**Public Contract
Application for
Contractual Changes
Contract Change Order # 1**

Project Name: Oak Crest Addition Sanitary Sewer And Water Line Improvements Project Number: S.23070
PO Number: 22501661 Date of Application: Thursday, December 11, 2025
Contractor: Timber Wolf Excavating, LLC Submitted By: Edmund Barlow, Project Mgr.

PLAN AND PROFILE - LINE 2
STA 66+00 TO 75+00

Dwg. No. **C-008**

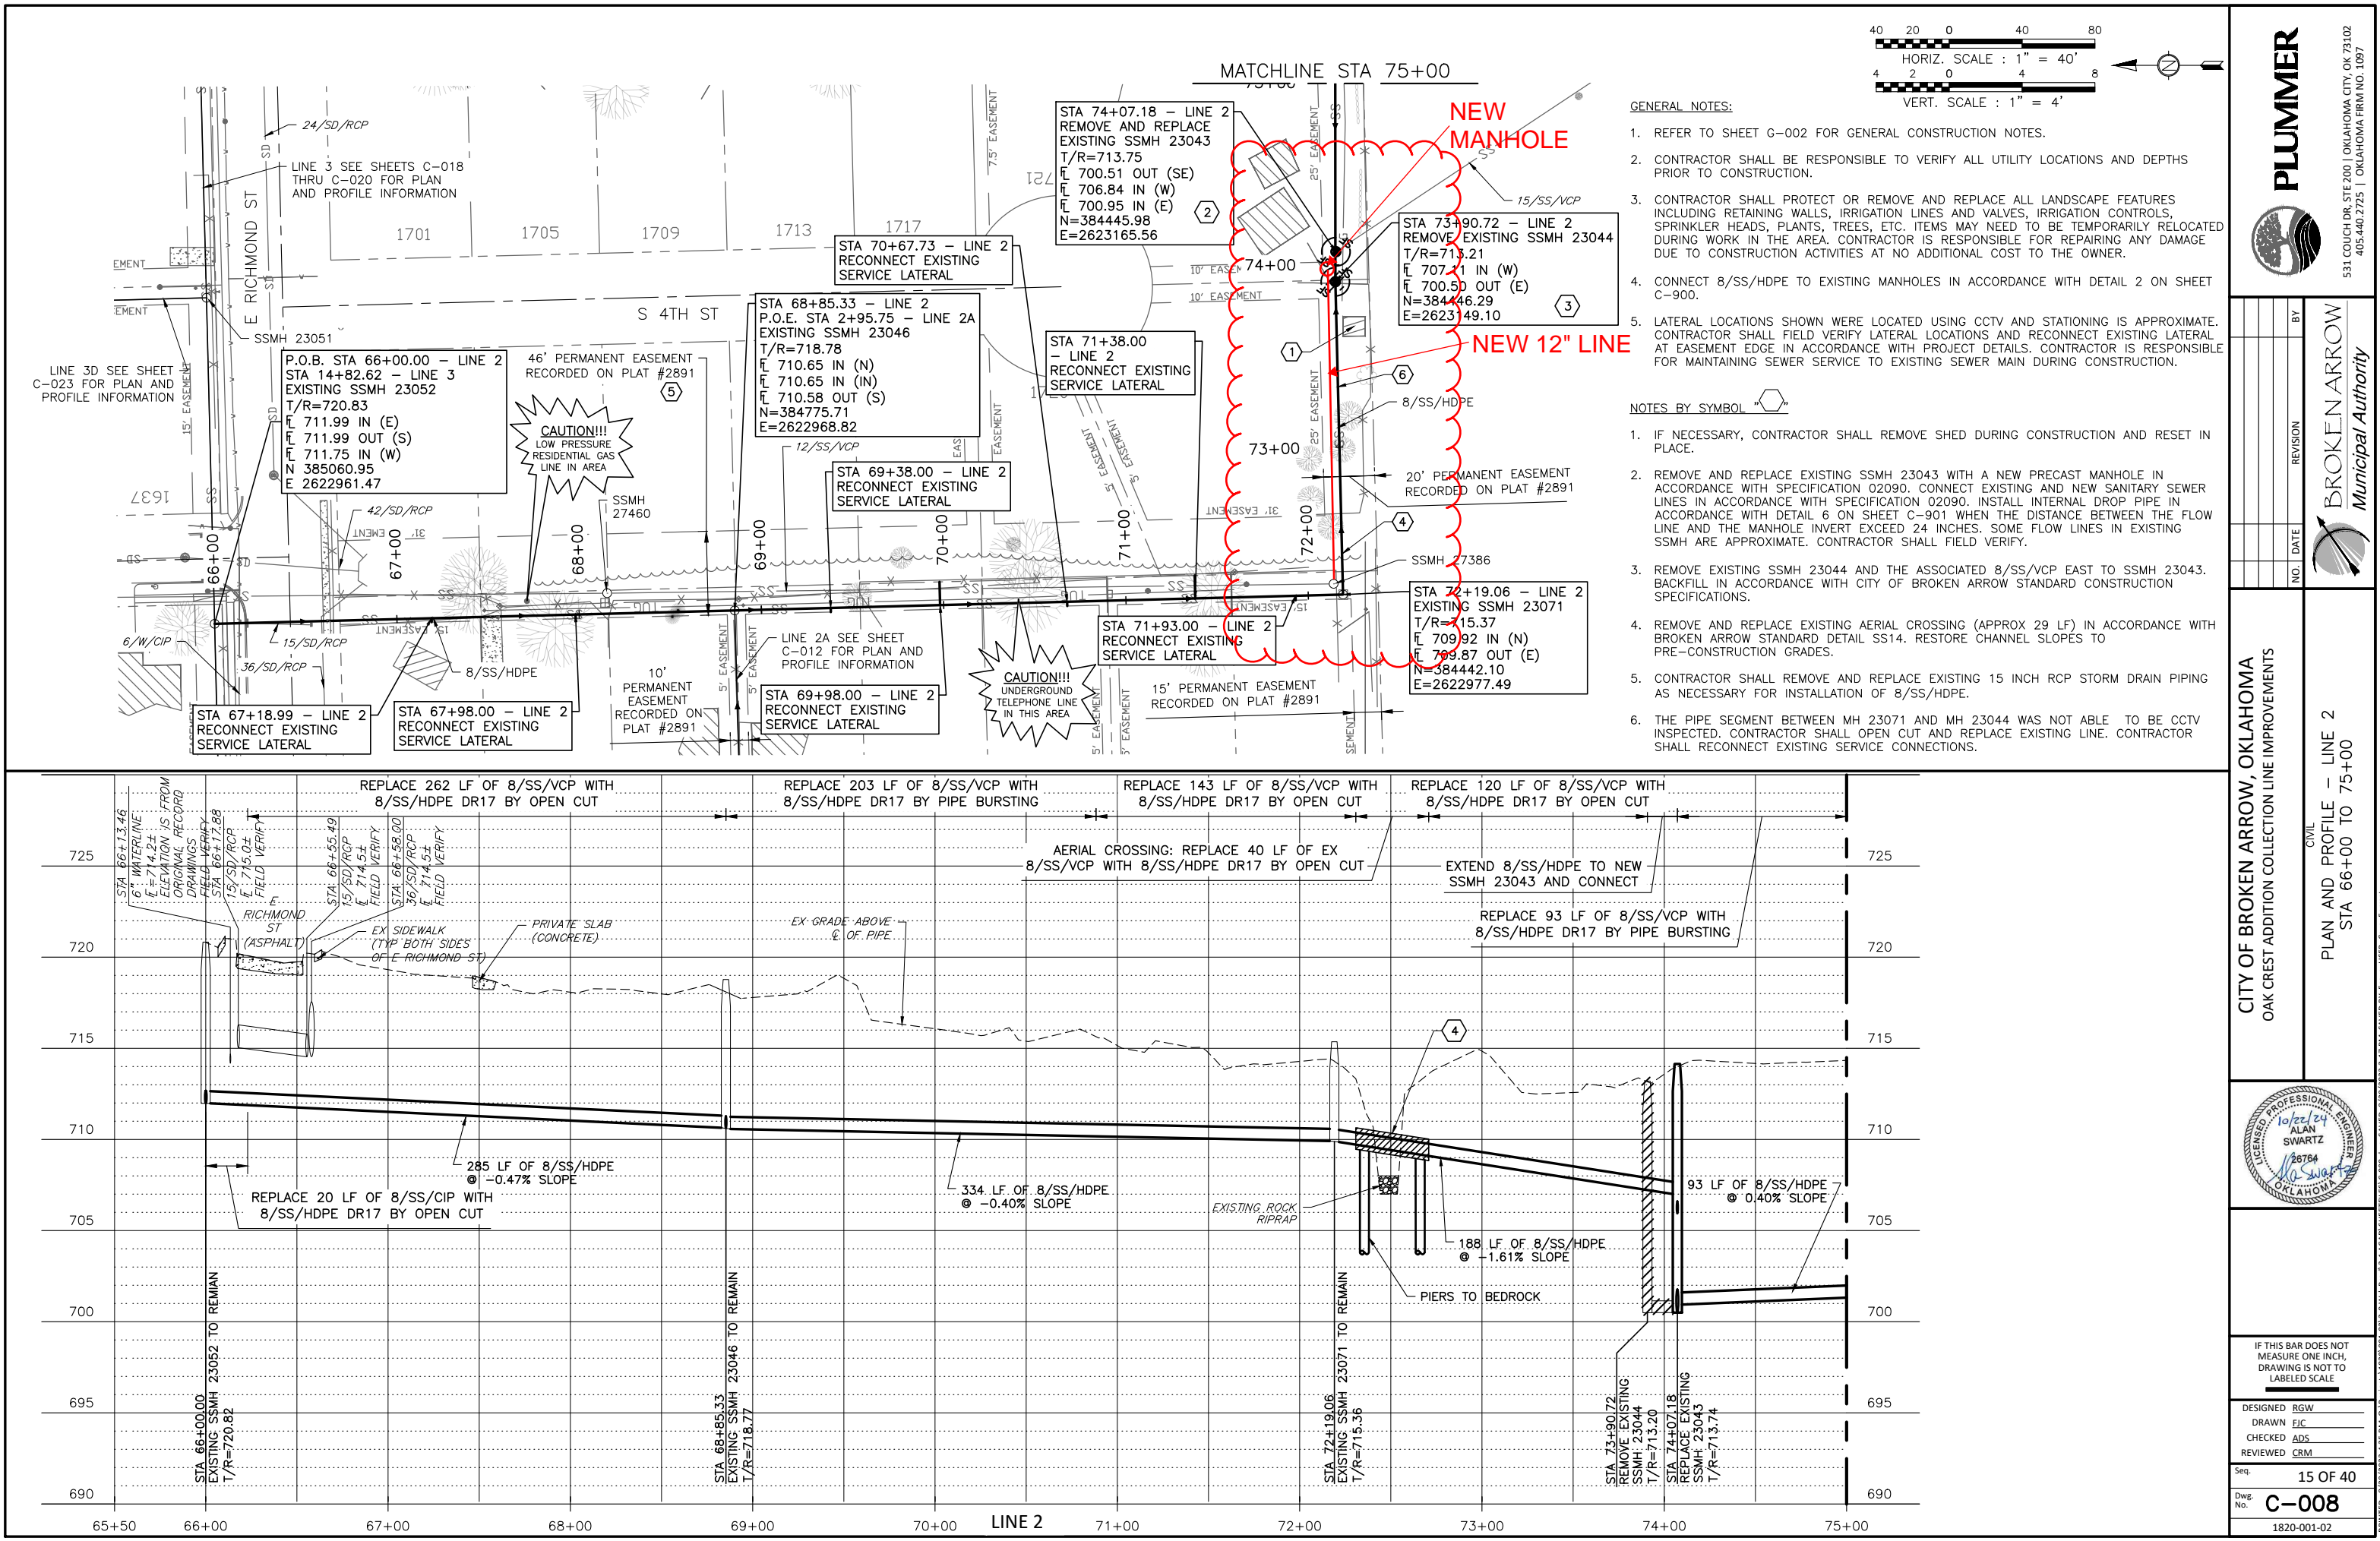
- 1) Install 240 LF of 12" HDPE sewer pipe on line 2, including up size casing pipe for creek crossing.
- 2) Install additional 4' drop manhole on line 2 at Sta 74+00. Approximate depth 8ft.
- 3)
- 4)
- 5)
